ADDENDUM NO. 02

Documents: MD101, M201.

UNIVERSITY OF SOUTH CAROLINA
UNION CAMPUS
BOILER REPLACEMENT

MECHANICAL/ELECTRICAL NEW WORK PLAN

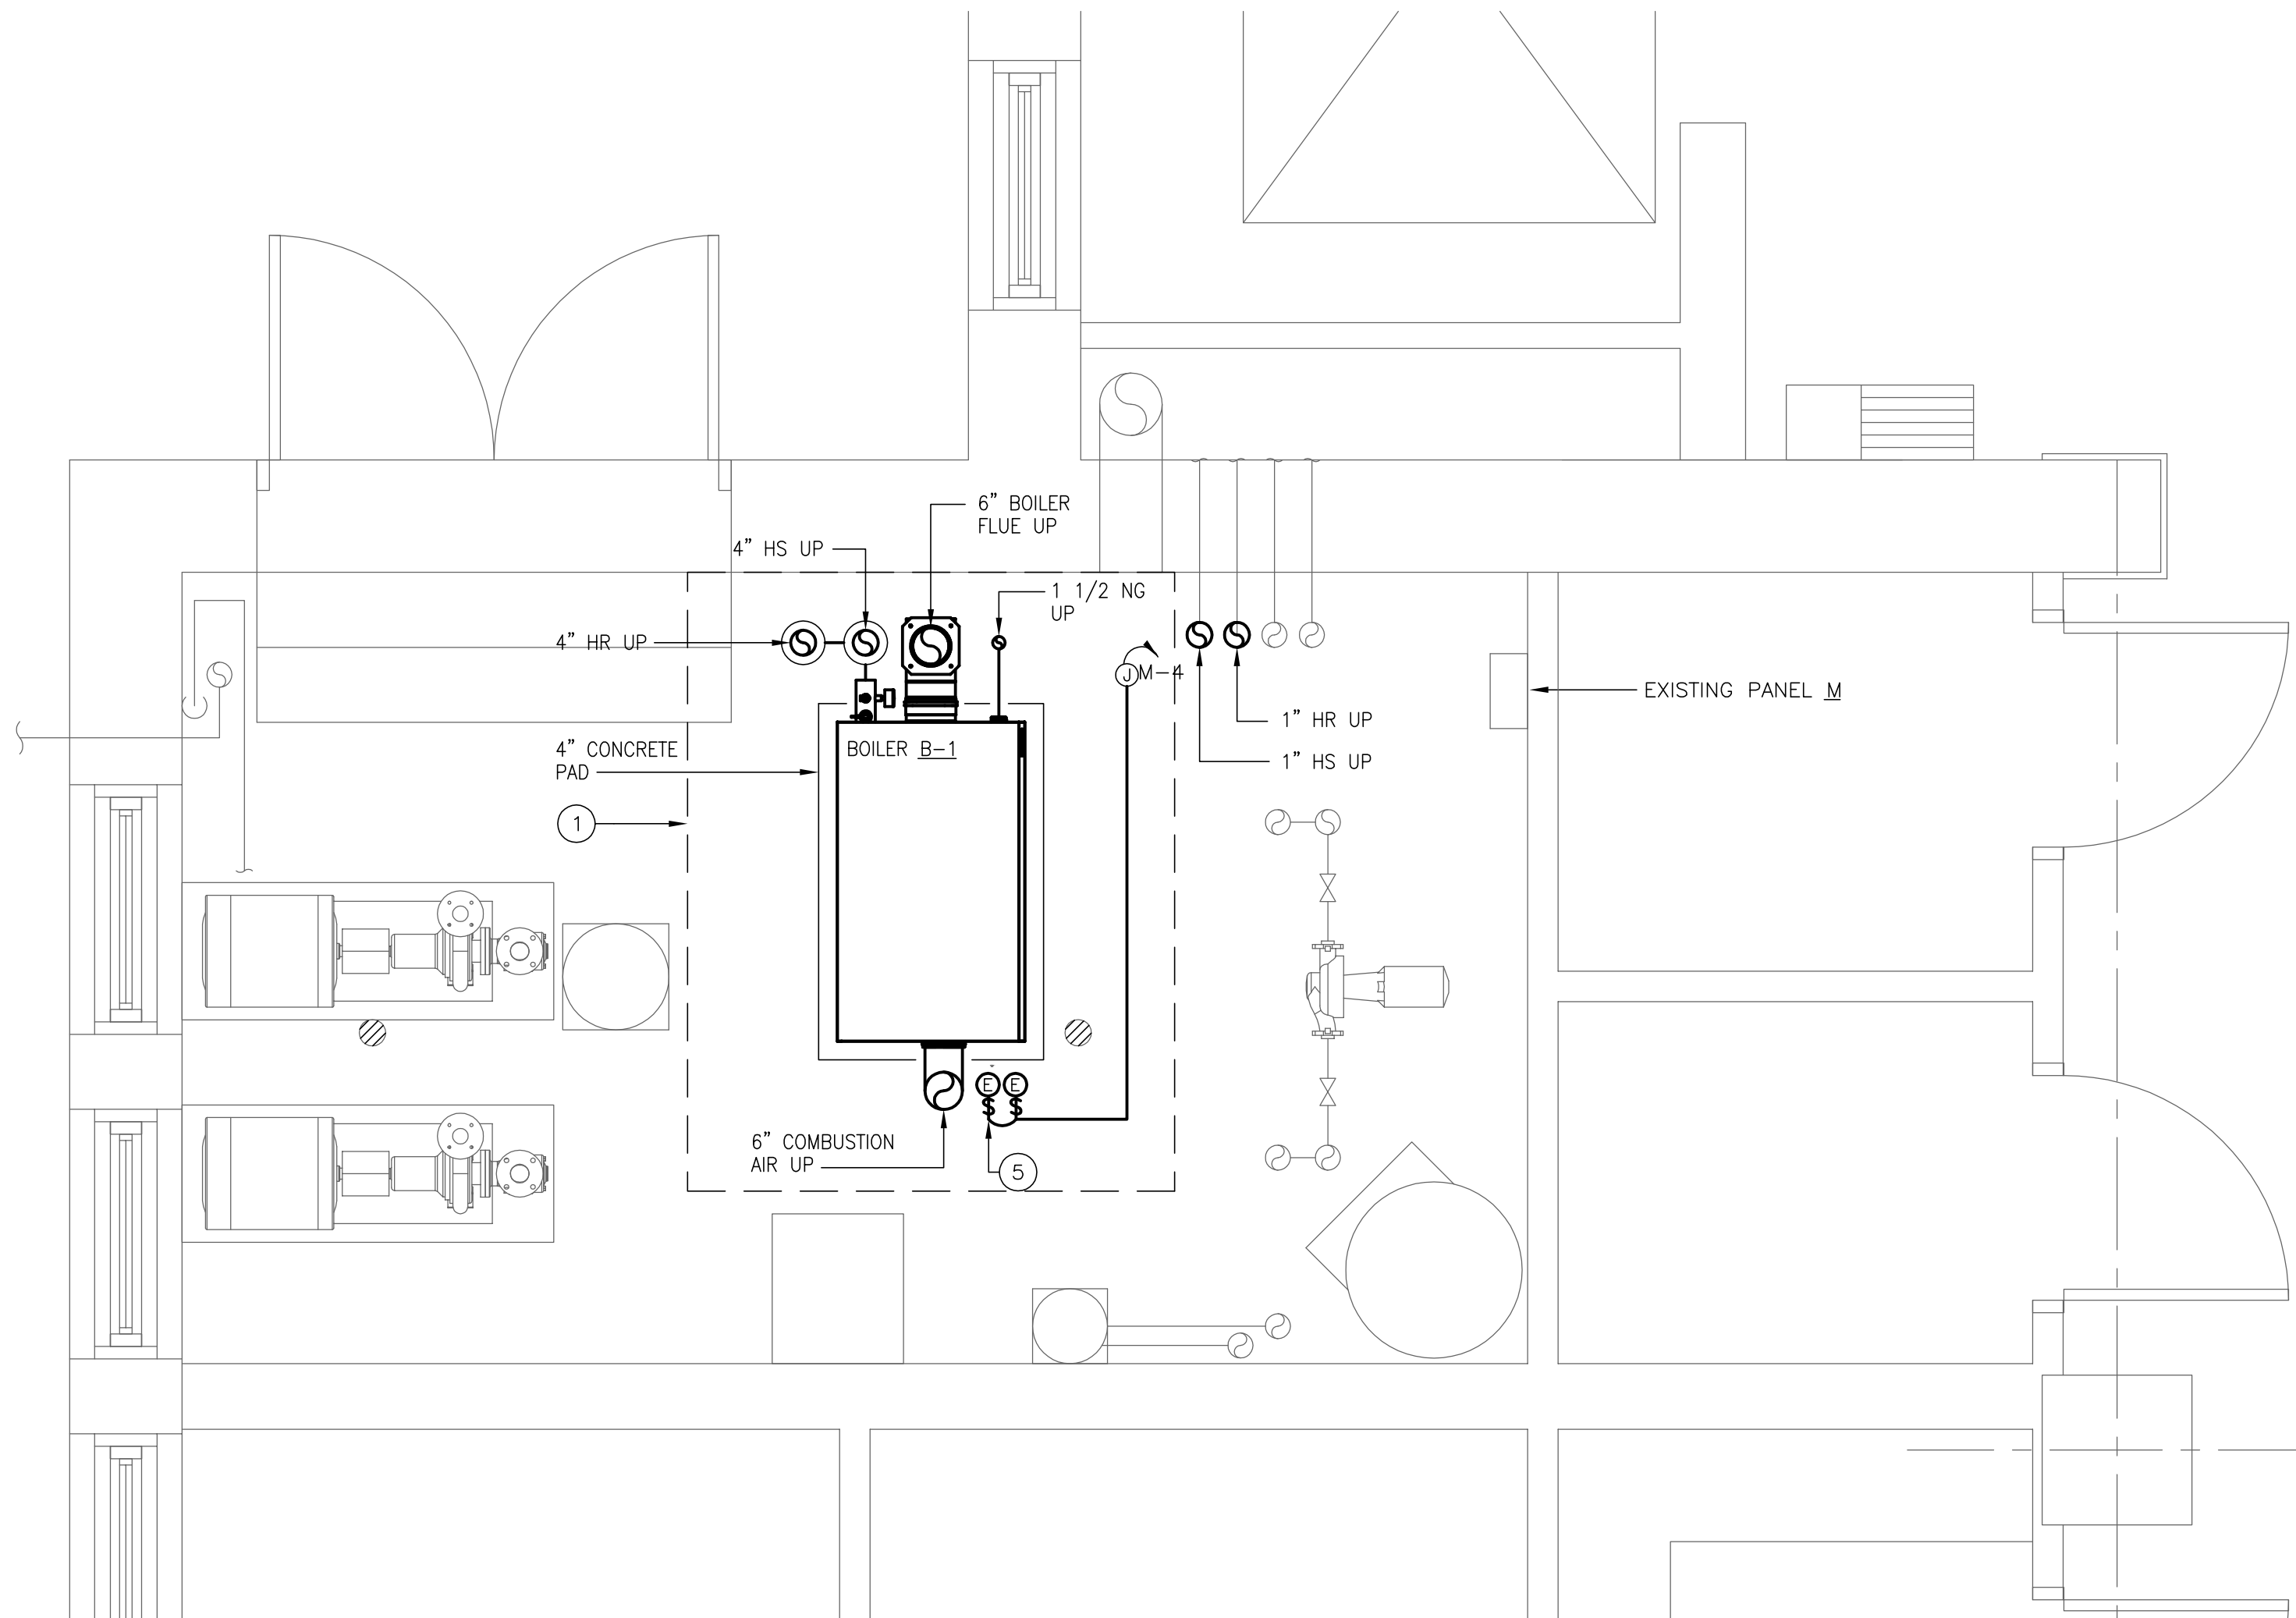
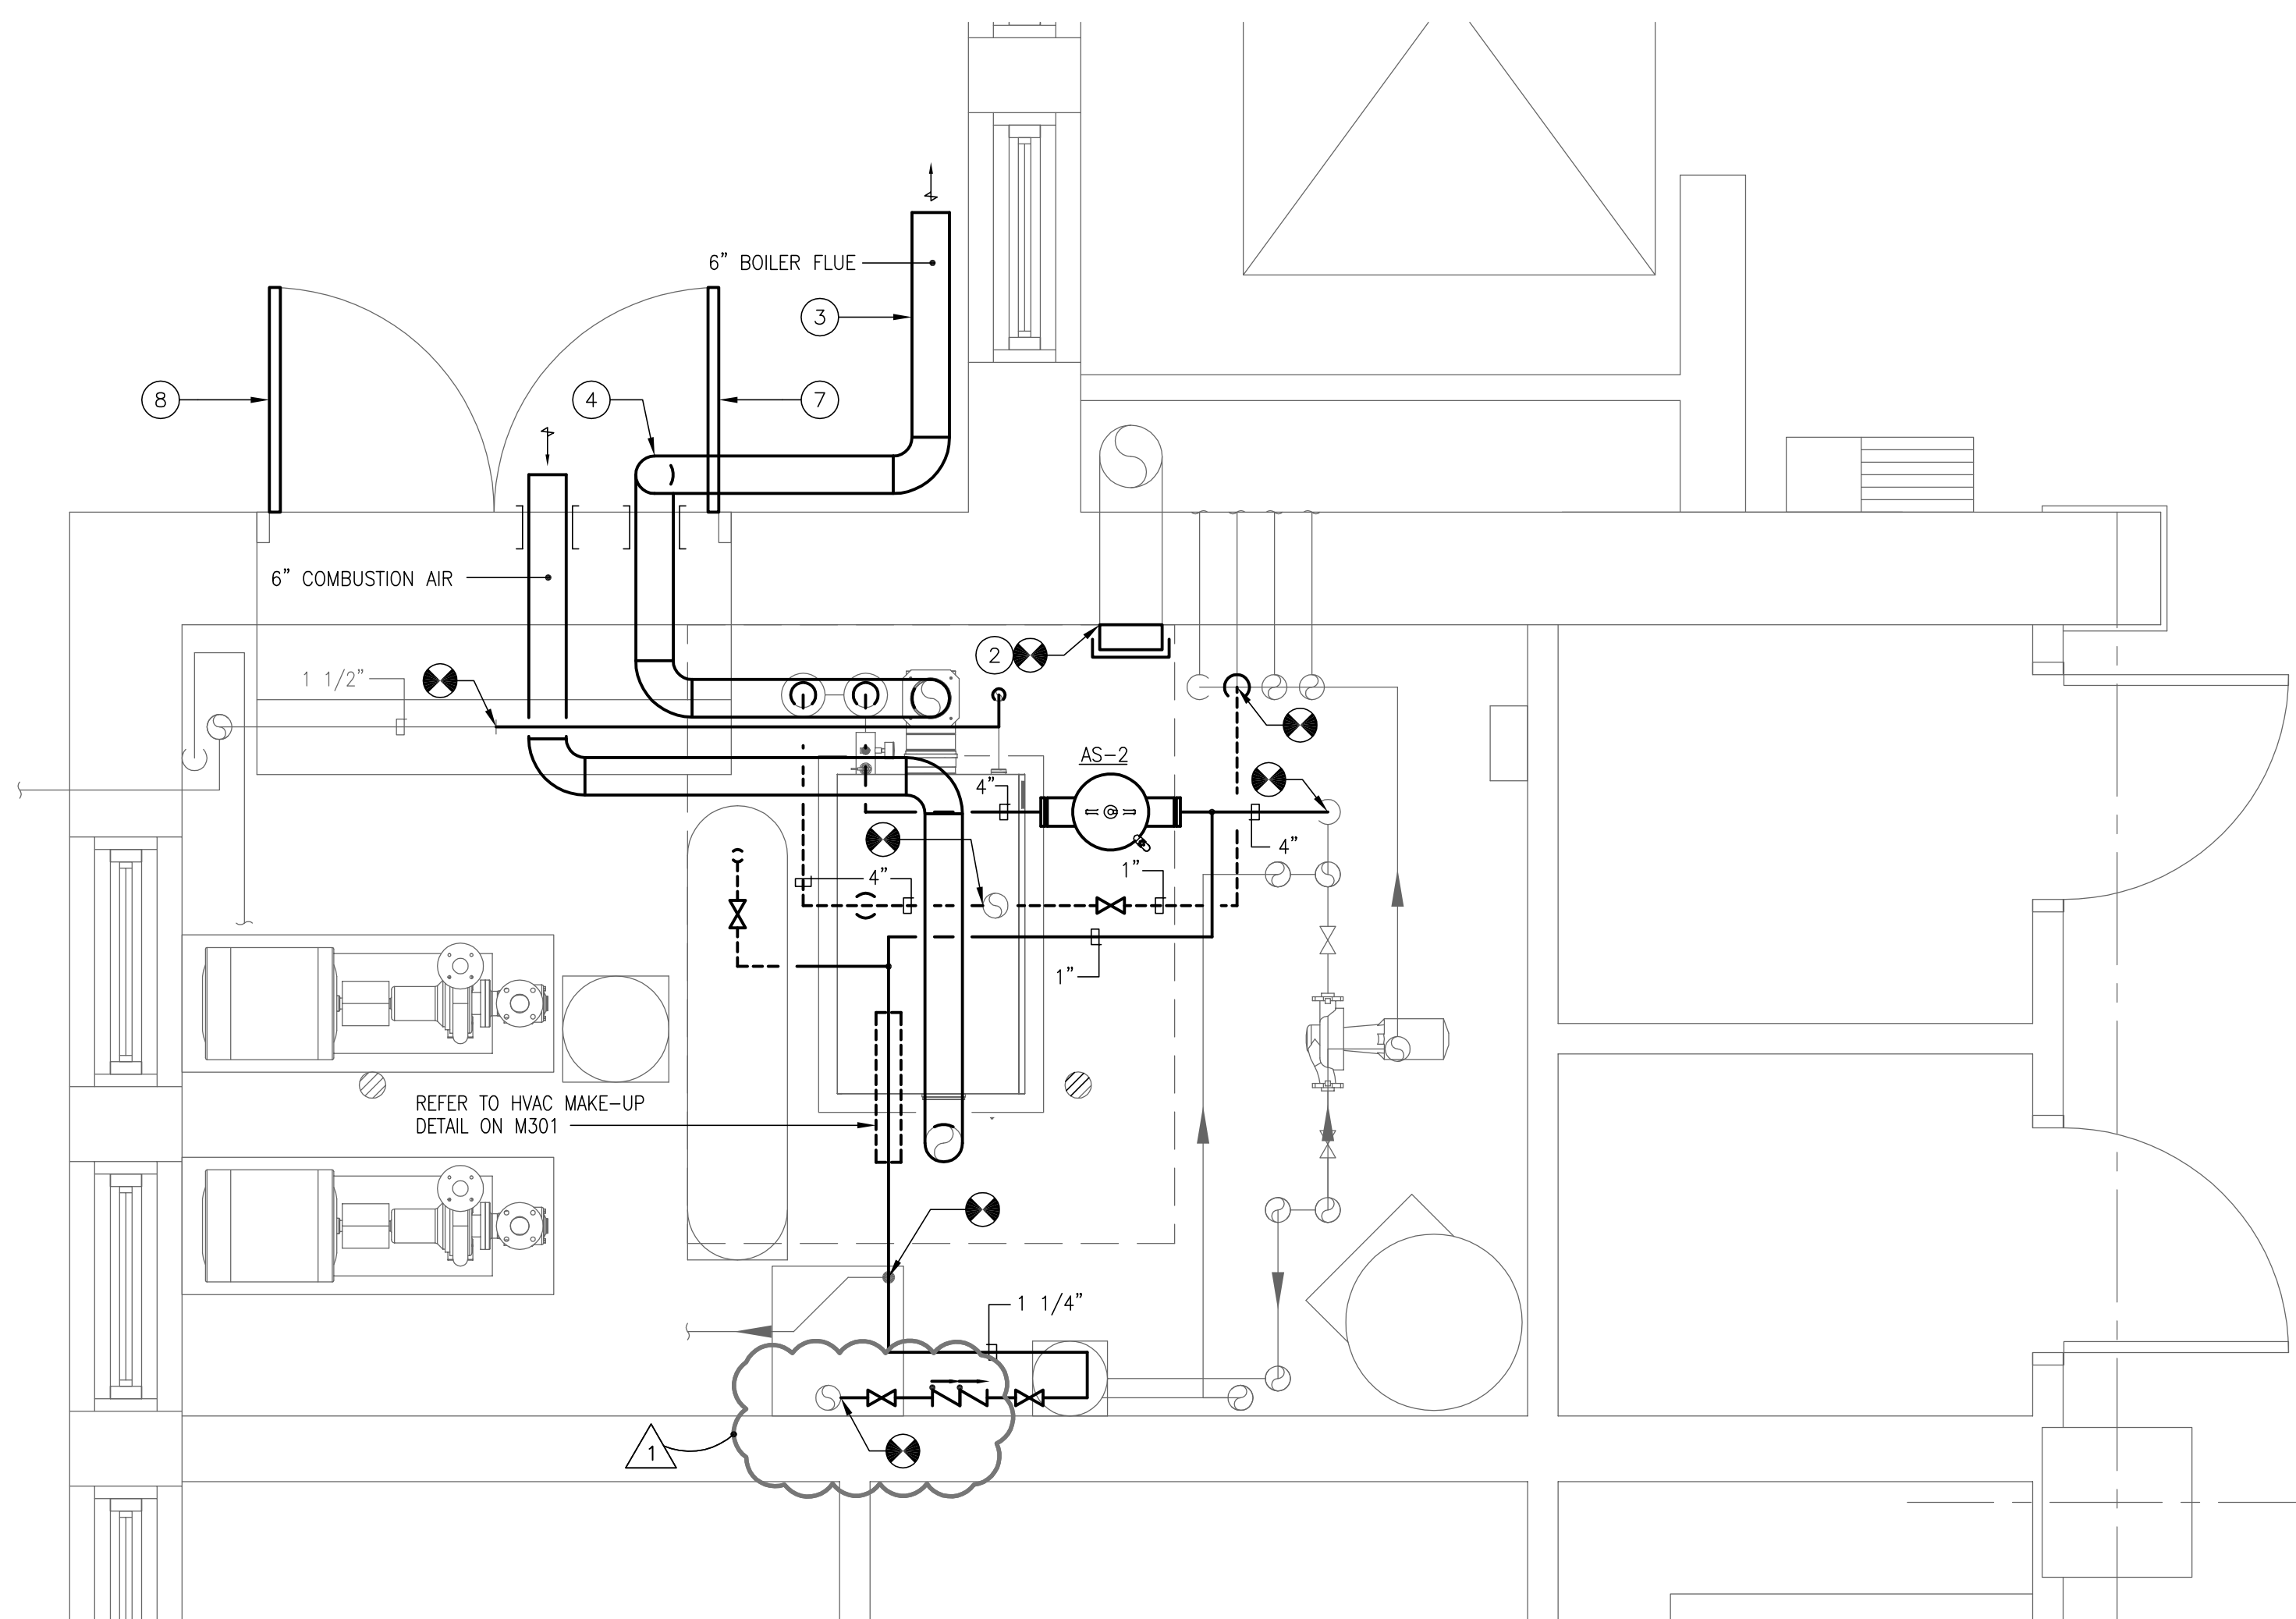
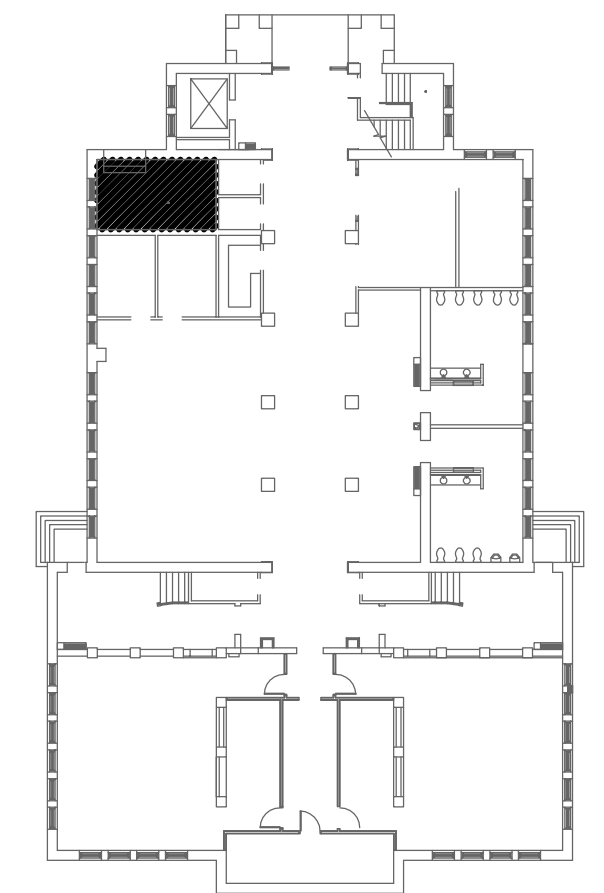
Response: No. The new Boiler will not tie into the existing BMS panel. Please refer to updated mechanical schematic attached to this addendum.
6. According to drawing M101 drawing note 5, only one 120V circuit is required to feed power to both the Boiler and the Boiler Recirculation Pump. Is this the intent?

Response: Yes.
7. What type of conduit is required for the installation?
Response: Please refer to Drawing Notes located on drawing M101.
8. Is there a Division 26 specification?

Response: There is not a Division 26 specification. All electrical information is listed on drawing MD101 and M101.
9. Does the combustion air inlet and the flue gas outlet need to have a 45* fitting with a bird screen on the end to keep rain and varmints out?

| 3. | M101 – MECHANICAL/ELECTRICAL NEW WORK PLAN Update drawing M101 to include domestic water valve as indicated by revision #1, Addendum #2, dated 10-24-2014. |

HEATING WATER SYSTEM SCHEMATIC AND CONTROL DIAGRAM

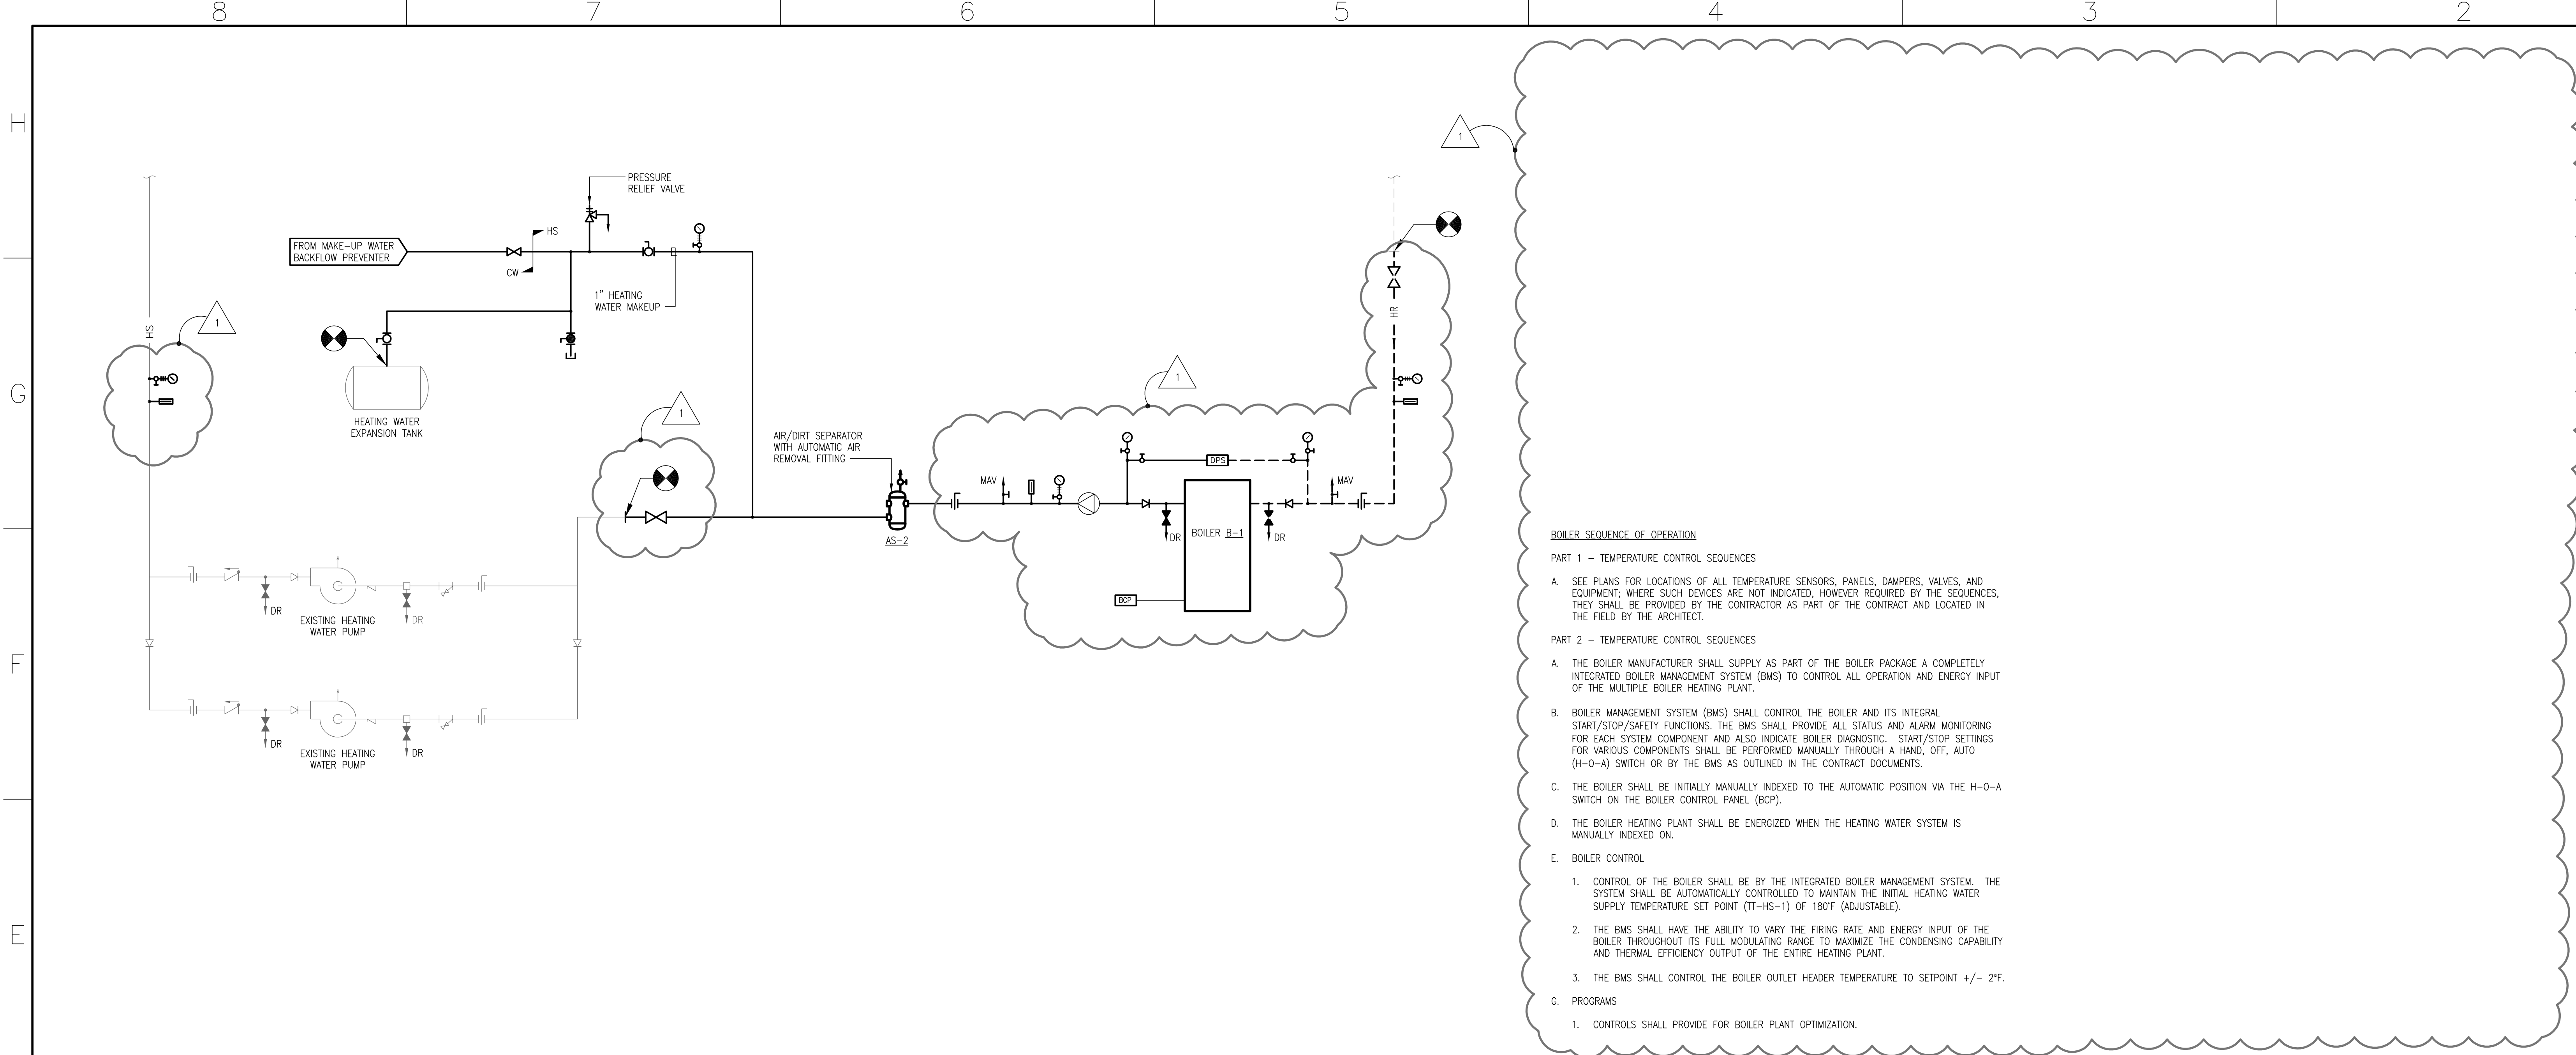
1. There appear to be (4) field devices that require control wiring: (2) temperature sensors/probes (I/O points 7 & 8), (1) differential pressure switch (I/O point 2) & (1) automatic butterfly valve with solenoid/actuator (I/O point 1). Is this correct?
Response: Please refer to updated mechanical schematic attached to this addendum.
2. If control wiring is required, can you provide the type control wiring required for each device? We're assuming all control wiring from these field devices go back to the BCP (Boiler Control Panel)...is this correct?
Response: The boiler shall be provided with integral control panel which will control boiler operation. Please refer to updated mechanical schematic attached to this addendum.

3. I can't readily see the control devices on the layout drawing. Can you provide locations for each of these devices, as well as, the Control Panel; or a nominal footage to use for bid purposes?

Response: Please refer to updated mechanical schematic attached to this addendum.
4. Are the point connections for 3, 4, 5 & 6 of the Input/Output Summary wired internal within the BCP? Is this Control Panel coming preassembled, prewired & preinstalled on the Boiler?

Response: Yes. Please refer to updated mechanical schematic attached to this addendum.
5. Is a communication gateway cable required between the new BCP and the existing system's BMS Panel? If so, what type cable and how far will the run be?

10. What type valves are required for the four inch (4") heating water supply and return at the existing tie-in points? Looks to be gate valves that will be removed in the demo.

| 1. | M201 – MECHANICAL SCHEMATICS Update drawing M201 to show schematic modifications as indicated by revision #1, Addendum #2, dated 10-24-2014. |

Response: Gate valves shall be located at the existing system tie-in points. Please refer to updated mechanical schematic attached to this addendum.
